UNITED STATES PATENT AND TRADEMARK OFFICE

APPLICATION NO.	FILING DATE	FIRST NAMED INVENTOR	ATTORNEY DOCKET NO.	CONFIRMATION NO.
10/585,709	07/10/2006	Byung-jin Chun	JCLA21326	7195
J.C.PATENTS 4 VENTURE, SUITE 250 IRVINE, CA 92618				
EXAMINER ROMAIN, PINEL E				
ART UNIT 3612				
PAPER NUMBER				
MAIL DATE 12/12/2008				
DELIVERY MODE PAPER

Office Action Summary

DETAILED ACTION

Reference A – Kim (Korean 1988-0003696)

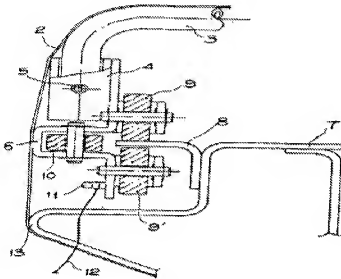
Consider claim 2, SATOMI discloses the apparatus according to claim 1, wherein the guide rail **(41, fig. 1)** includes: a rail frame (42, fig. 6f) having a shape of "c", the rail frame (42, fig.6f)being installed on each top end of both side walls of the container. However SATOMI does not disclose a guide having a shape "upside down reverse L" of the guide **(41, fig. 1)** being formed on an inner side of a center part of the rail frame to guide the slide of the cover supporting member. Kim discloses a guide (7, reference A, shown below) having a shape "The upside down reverse "L" attached to side of the guide. It would have been obvious to one of ordinary skill in the art at the time of the invention was made to modify the apparatus in claim 1 taught by SATOMI with the inner center guide (7, reference, fig. A) taught by KIM to achieve to

achieve the claimed invention wherein, the bow would have increase stability and reduce binding of the rollers.

discloses a plurality of rollers (Reference A, above in claim 2) slidable along an upper surface (8, reference A). Kim further discloses both side surfaces of the guide rail (41, fig.1), respectively and a roller supporting member (3, Reference A, above in claim 2) extended to the connecting member (3, Reference A, above in claim 2) to rotatably support each of the rollers. It would have been obvious to one of ordinary skill in the art at the time of the invention was made to modify apparatus in claim 4 taught by SATOMI with the plurality of rollers taught by KIM to achieve the claimed invention, whereby maintain the rollers free of dirt and sand, thus preventing binding of the cover when opening and closing the top.

spaced in parallel with the second roller supporting part, to rotatably support the roller slide along the other side surface of the guide. (see fig. below, Kim 1988003696). It would have been obvious to one of ordinary skill in the art at the time of the invention was made motivated to modify apparatus in claim 4 taught by SATOMI with additional rollers taught by KIM to achieve the claimed invention, whereby, the additional rollers would reduce the binding of the cover while being in operations.
